S4.55 MODIFICATION

S4.55 MODIFICATIONS	
Change ID	Name
Ch-01	Courtyard wall moved into courtyard
Ch-02	Alfresco deck reshaped
Ch-03	New window to first floor bathroom (W29)
Ch-04	Western wall on first floor moved forward by 650mm & balcony removed
Ch-05	New window to ground floor Dining (W20)
Ch-06	W04 - Kitchen window size change
Ch-07	Skylights relocated from stairwell to hallway
Ch-08	Eastern balcony screen reduced in length
Ch-09	Cellar footprint revised to include sauna

S4.55 MODIFICATION		
project	1130 PITTWATER RD	
	COLLAROY	
drawing	COVER SHEET	
drawn	SM / PC	checked MA
date	09.02.24	scale @ A3
project no	2_23_10	drawing no D0000
		issue F

project	S4.55 MODIFICATION
project	1130 PITTWATER RD
drawing	COLLAROY
drawn	SM / PC
checked	MA
date	09.02.24
scale	1:100 @ A3
project no	2_23_10
drawing no	D3002
issue	F

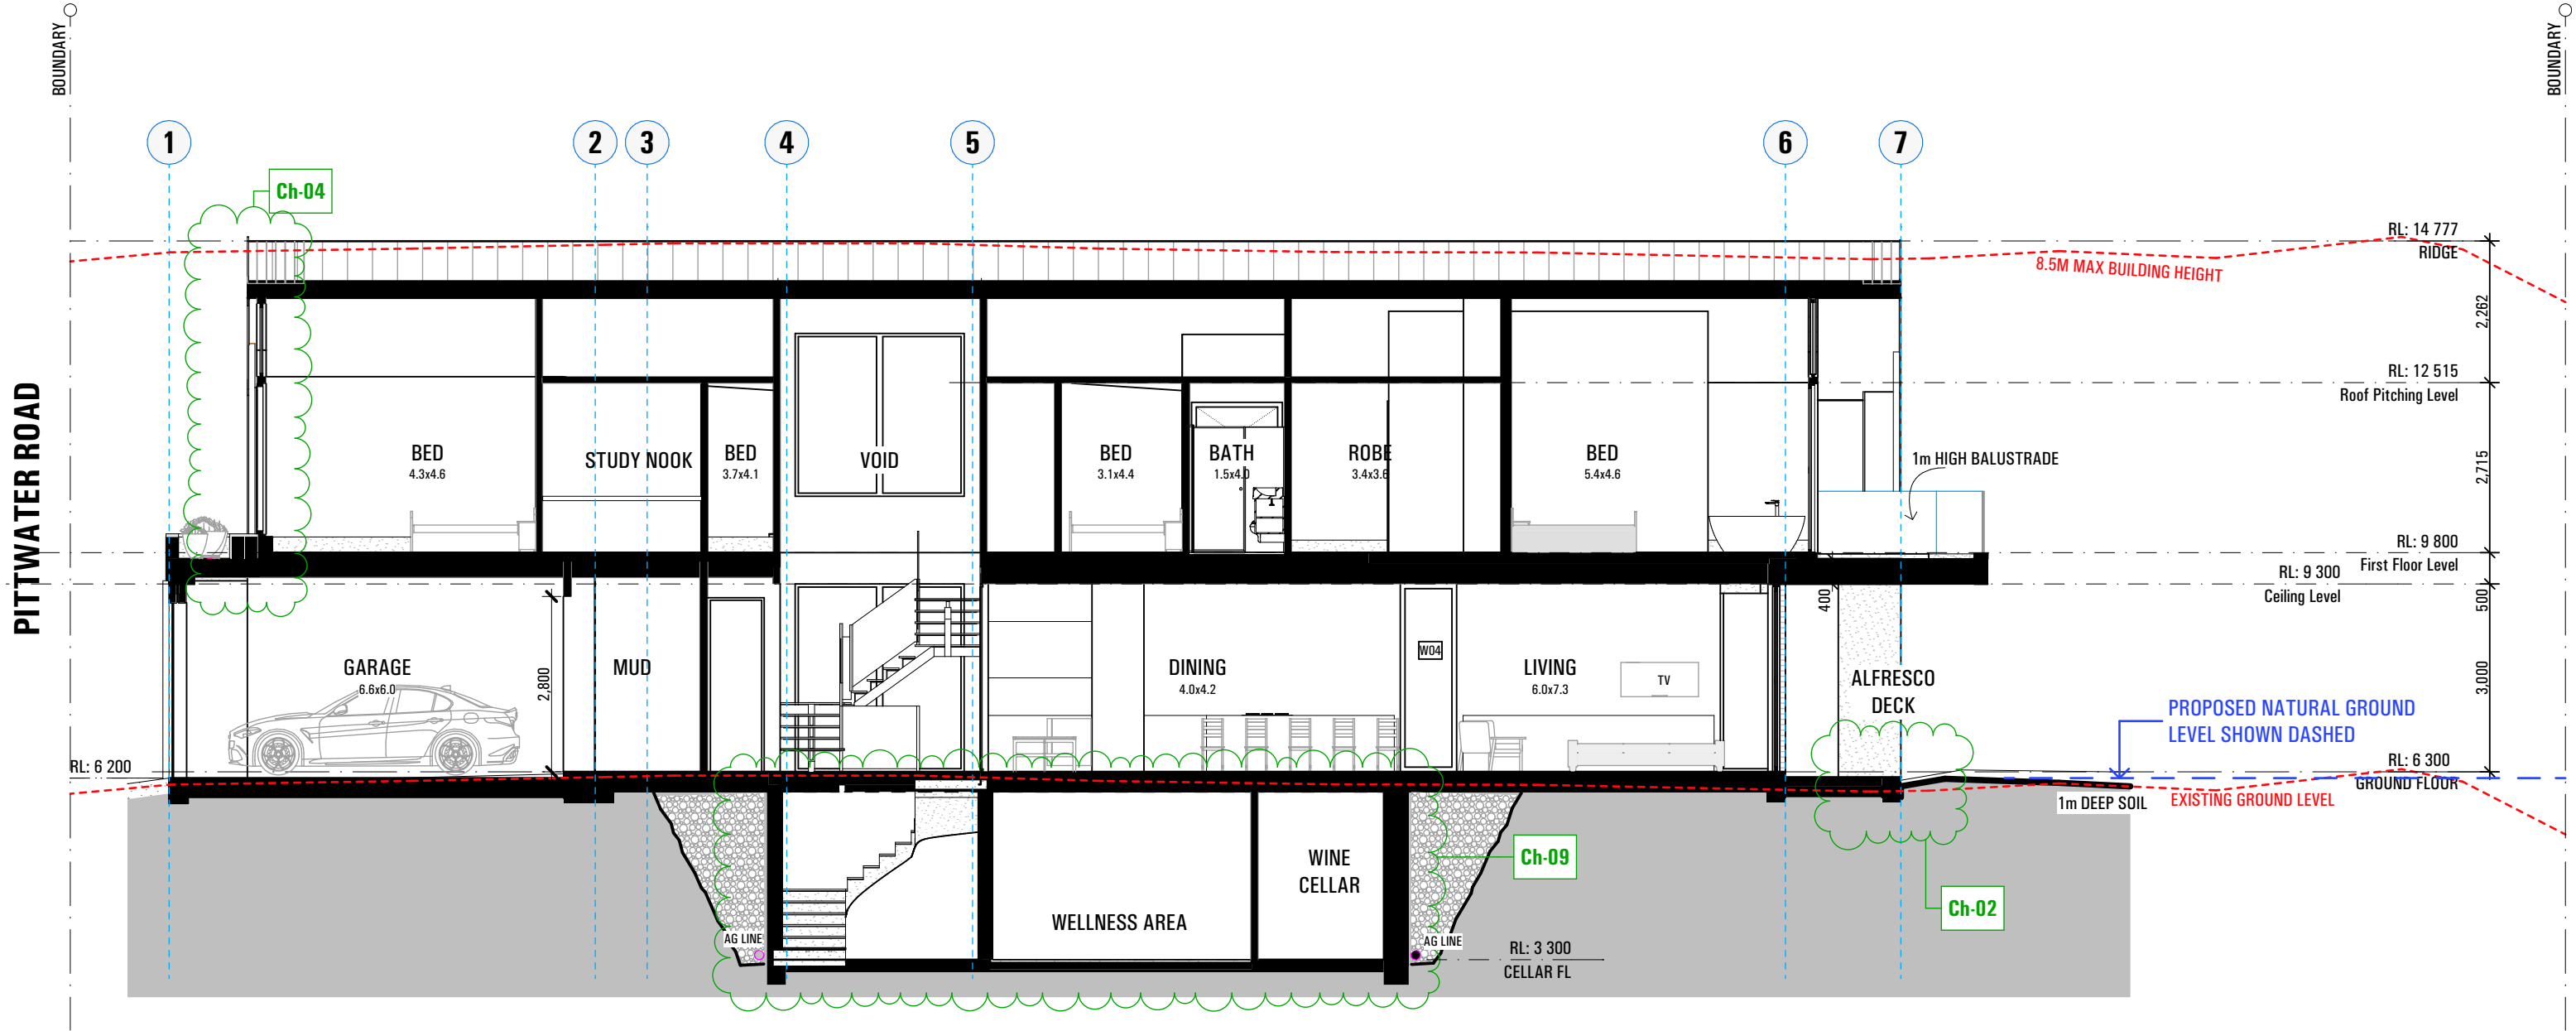
S4.55 MODIFICATIONS	
Change ID	Name
Ch-01	Courtyard wall moved into courtyard
Ch-02	Alfresco deck reshaped
Ch-03	New window to first floor bathroom (W29)
Ch-04	Western wall on first floor moved forward by 650mm & balcony removed
Ch-05	New window to ground floor Dining (W20)
Ch-06	W04 - Kitchen window size change
Ch-07	Skylights relocated from stairwell to hallway
Ch-08	Eastern balcony screen reduced in length
Ch-09	Cellar footprint revised to include sauna

drawing noD3100

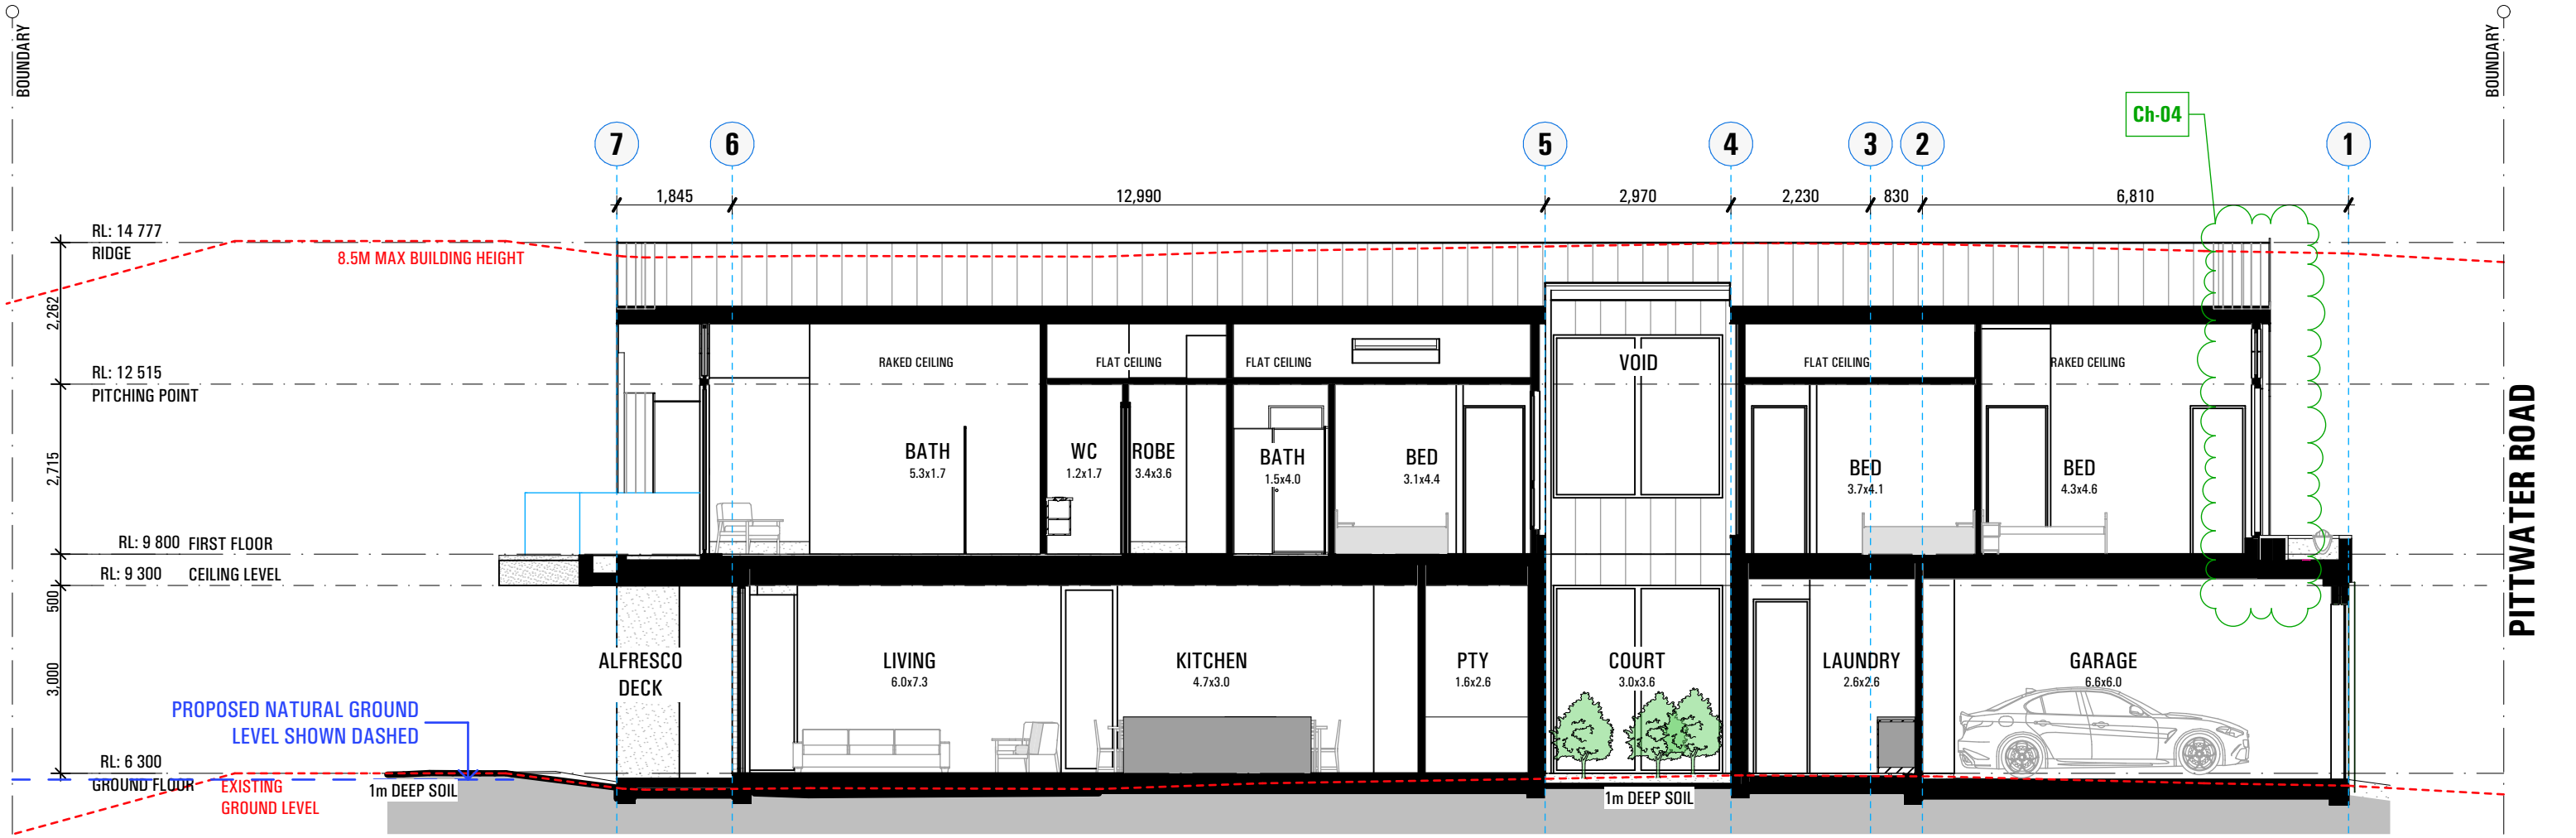
S4.55 MODIFICATIONS	
Change ID	Name
Ch-01	Courtyard wall moved into courtyard
Ch-02	Alfresco deck reshaped
Ch-03	New window to first floor bathroom (W29)
Ch-04	Western wall on first floor moved forward by 650mm & balcony removed
Ch-05	New window to ground floor Dining (W20)
Ch-06	W04 - Kitchen window size change
Ch-07	Skylights relocated from stairwell to hallway
Ch-08	Eastern balcony screen reduced in length
Ch-09	Cellar footprint revised to include sauna

project no 2_23_10 drawing no D3101 issue F

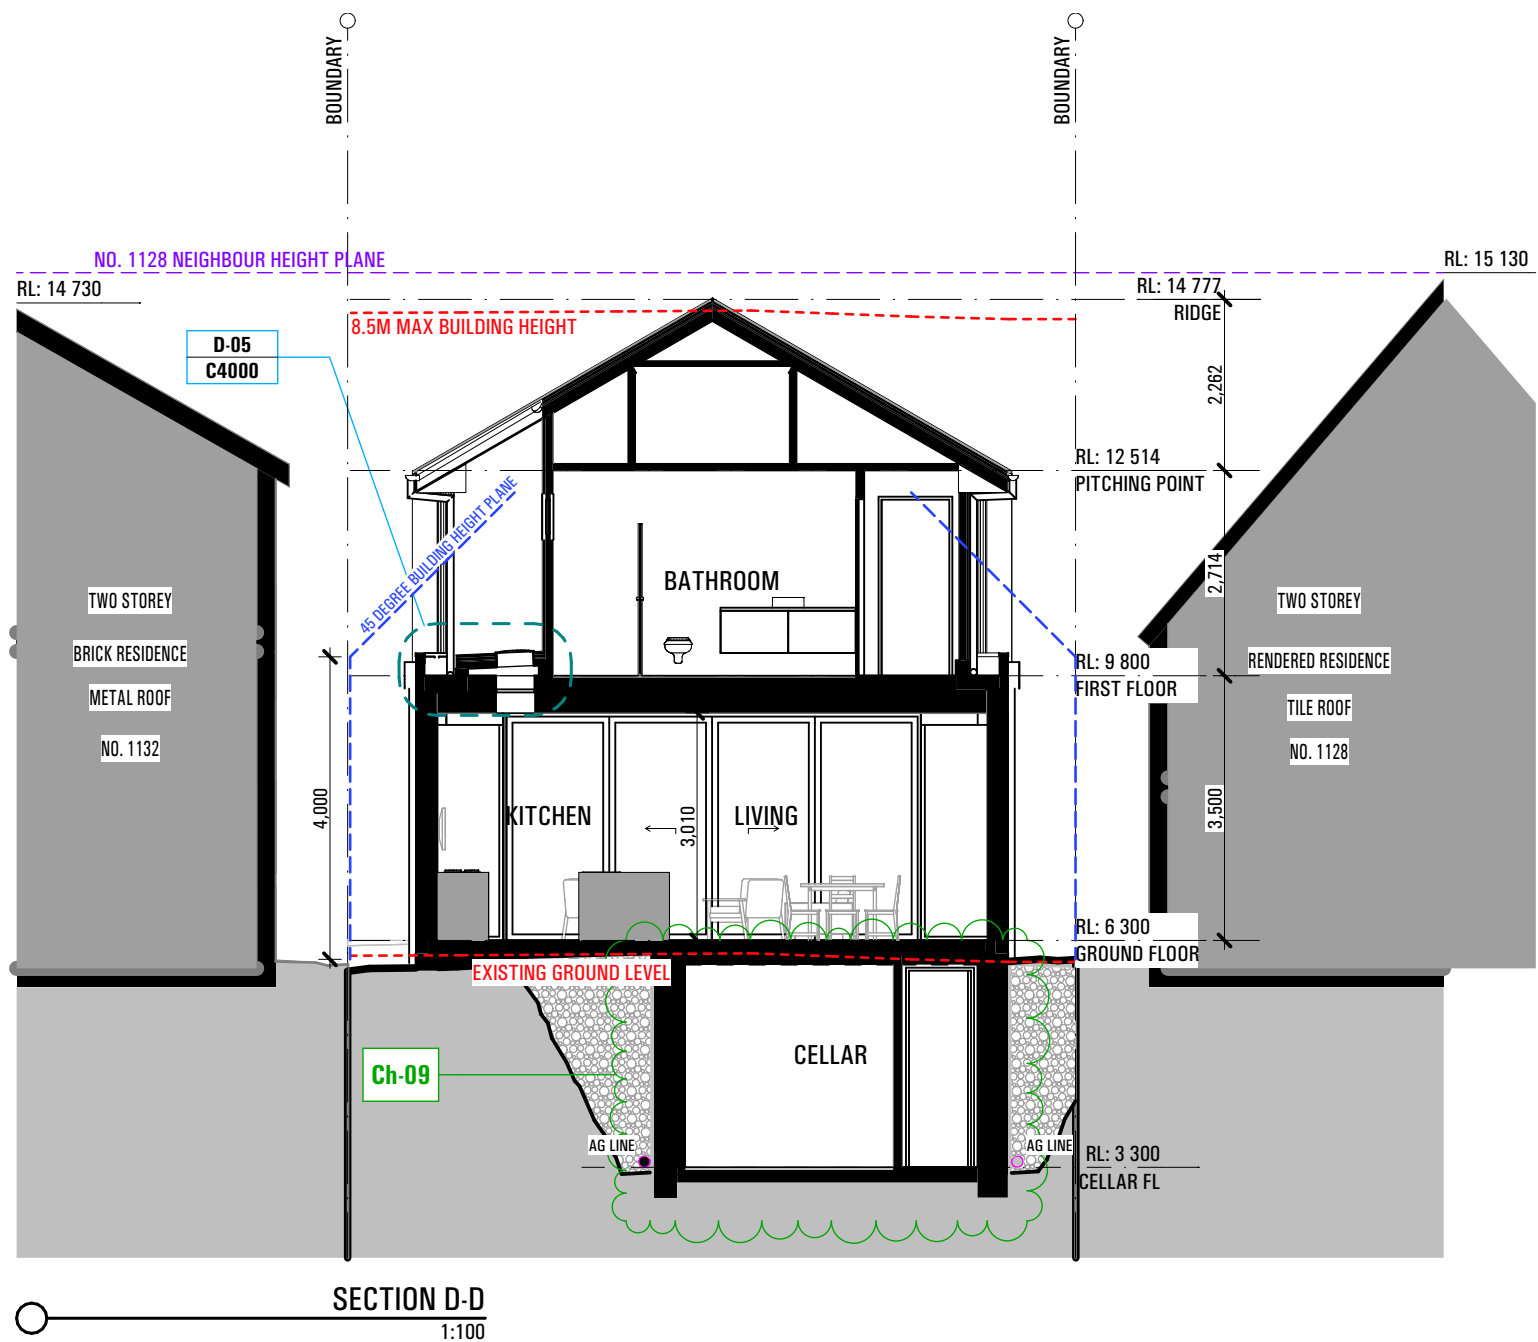
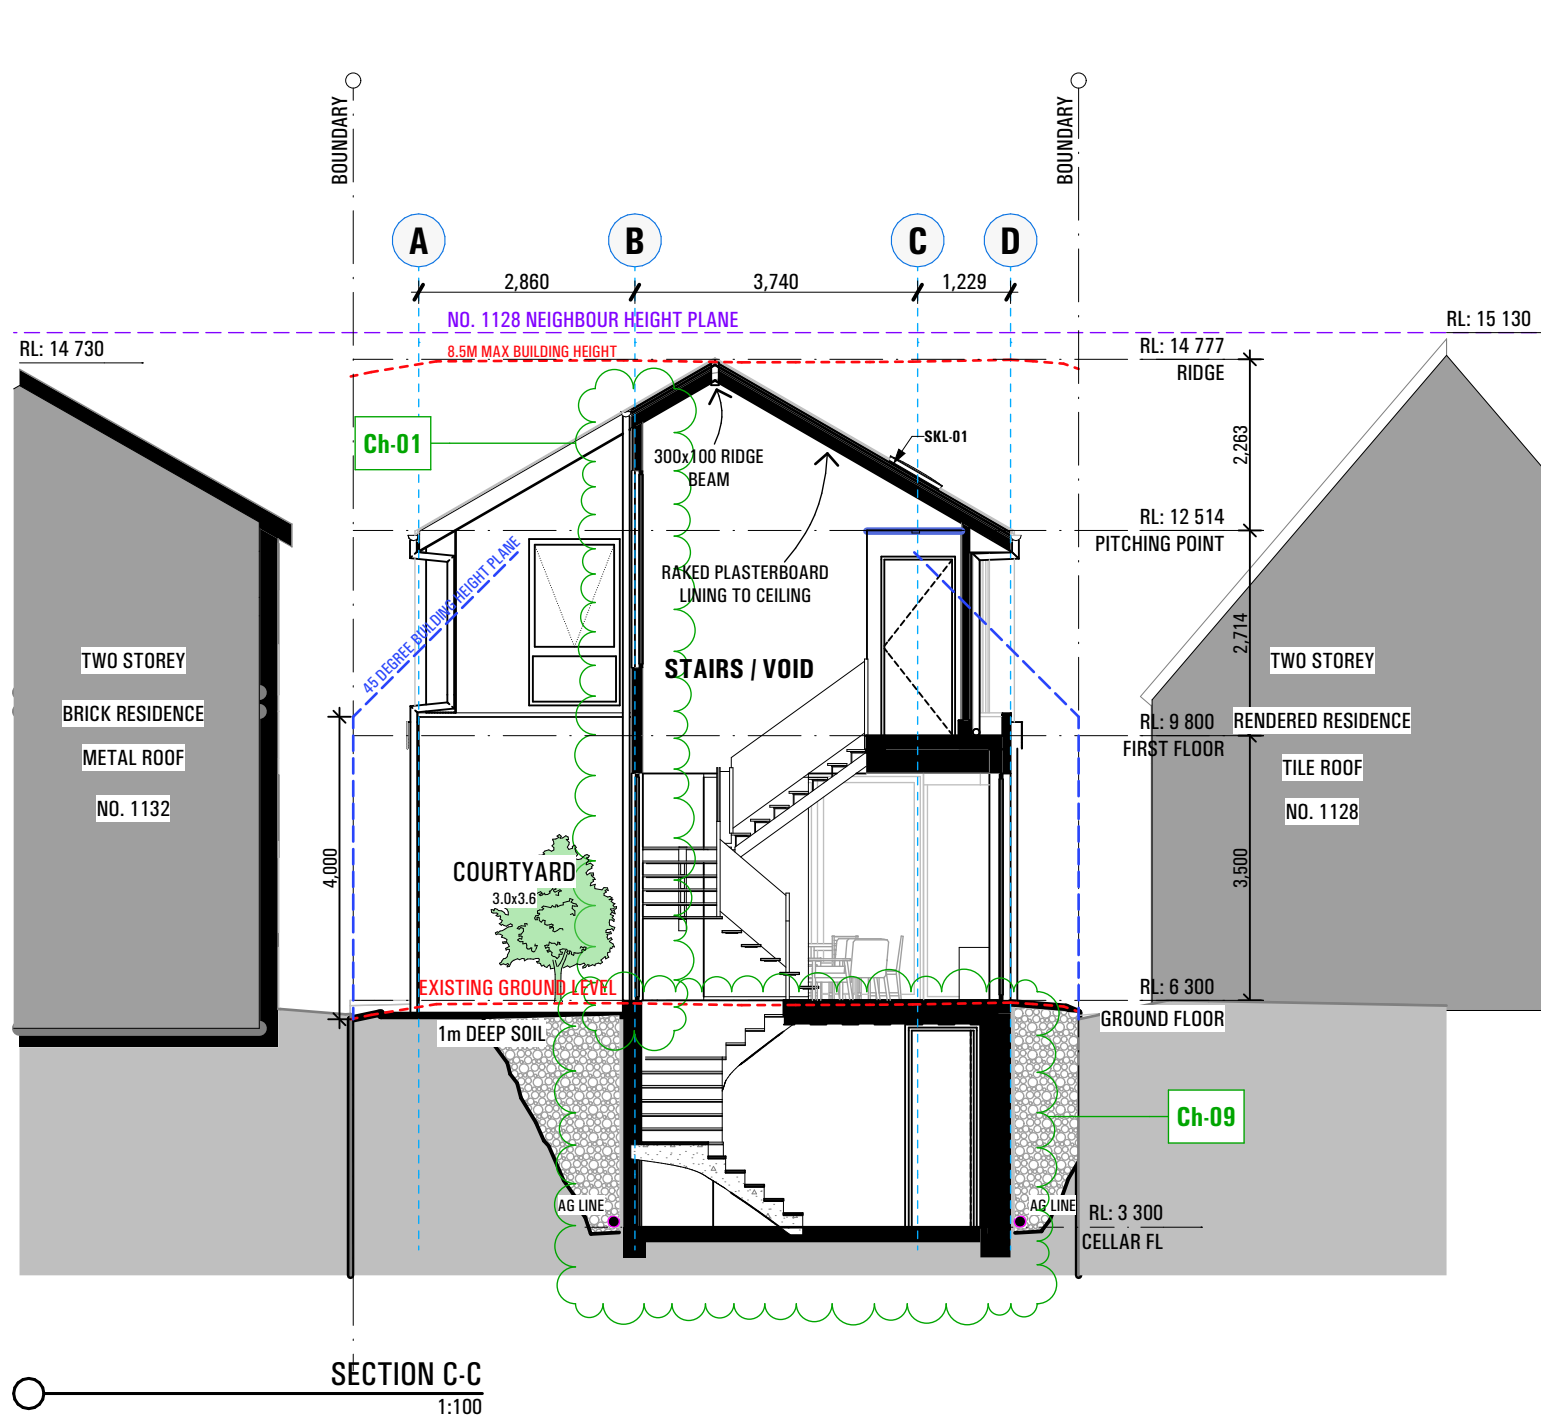
S4.55 MODIFICATIONS		
Change ID	Name	
Ch-01	Courtyard wall moved into courtyard	
Ch-02	Alfresco deck reshaped	
Ch-03	New window to first floor bathroom (W29)	
Ch-04	Western wall on first floor moved forward by 650mm & balcony removed	
Ch-05	New window to ground floor Dining (W20)	
Ch-06	W04 - Kitchen window size change	
Ch-07	Skylights relocated from stairwell to hallway	
Ch-08	Eastern balcony screen reduced in length	
Ch-09	Cellar footprint revised to include sauna

S4.55 MODIFICATION			
project	1130 PITTWATER RD		
	drawing		
	COLLAROY		
AREA SCHEDULE			
drawn	SM / PC	checked	MA
date	09.02.24	scale	1:150 @ A3
project no	drawing no	issue no	
2 23 10	D5000	F

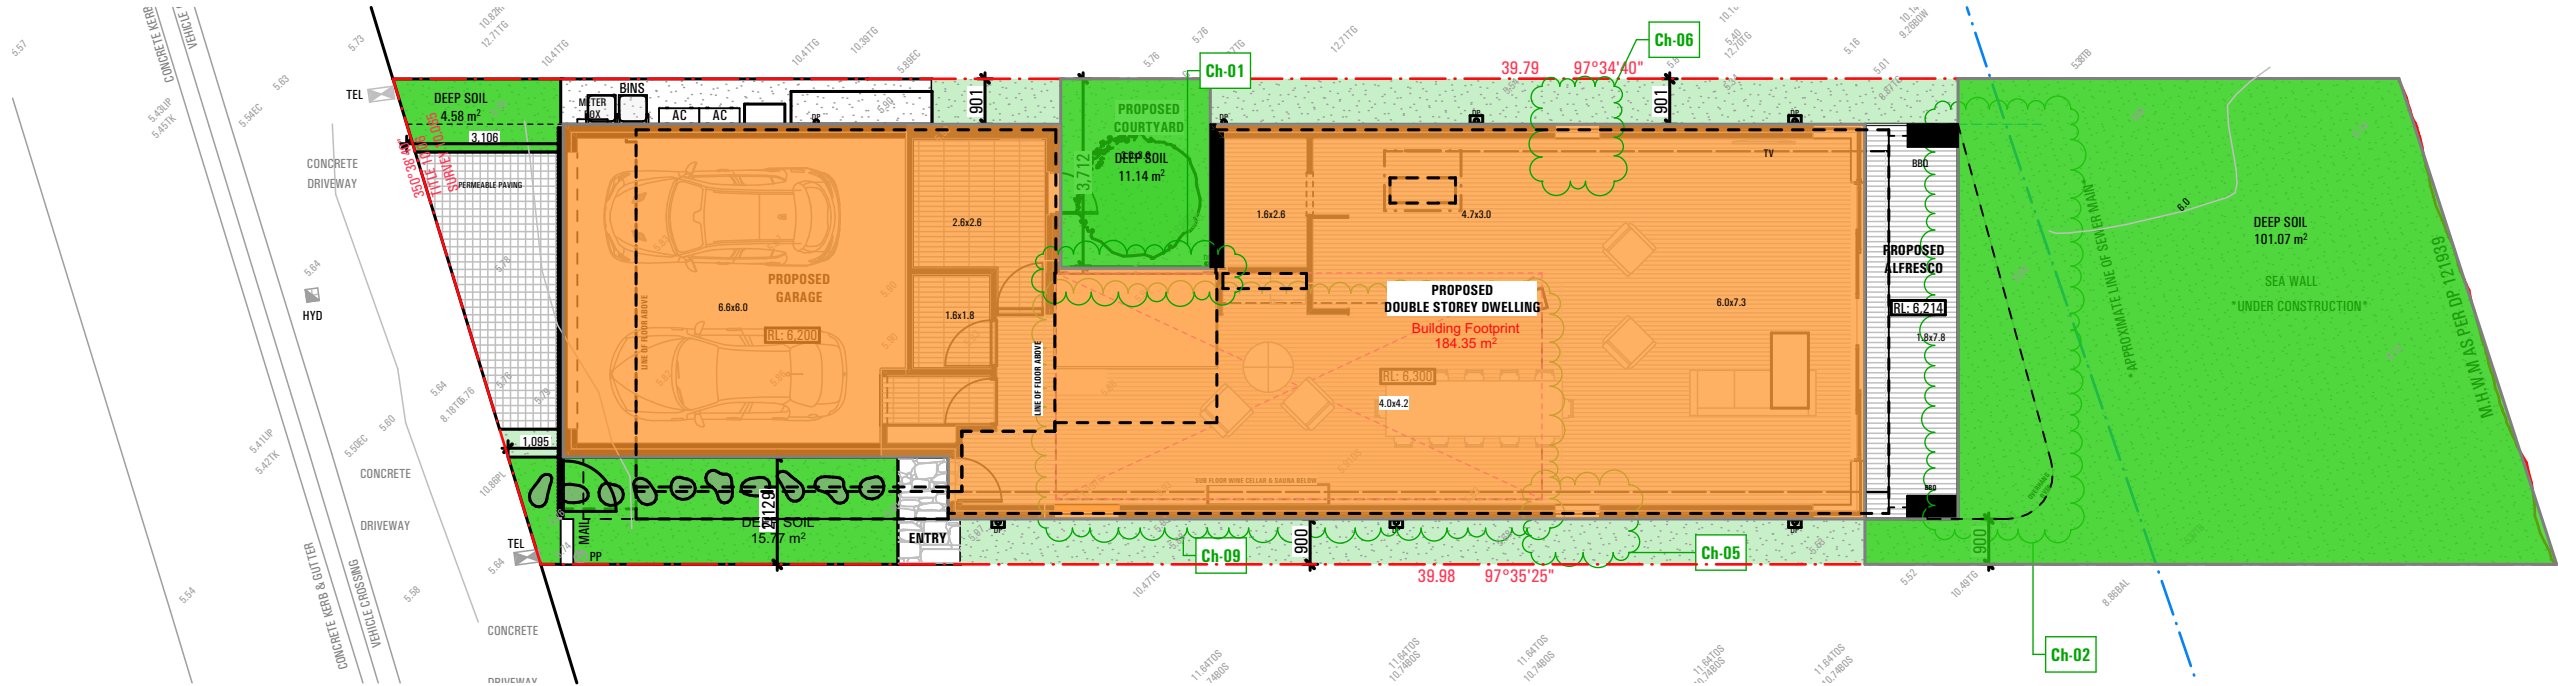
REQUIRED: 154.28m² (40% x SITE AREA)
PROPOSED (DA Approved): 132.01m² (34.2%)
PROPOSED (S4.55 Modification): 132.56m² (34.4%)

S4.55 MODIFICATIONS	
Change ID	Name
Ch-01	Courtyard wall moved into courtyard
Ch-02	Alfresco deck reshaped
Ch-03	New window to first floor bathroom (W29)
Ch-04	Western wall on first floor moved forward by 650mm & balcony removed
Ch-05	New window to ground floor Dining (W20)
Ch-06	W04 - Kitchen window size change
Ch-07	Skylights relocated from stairwell to hallway
Ch-08	Eastern balcony screen reduced in length
Ch-09	Cellar footprint revised to include sauna
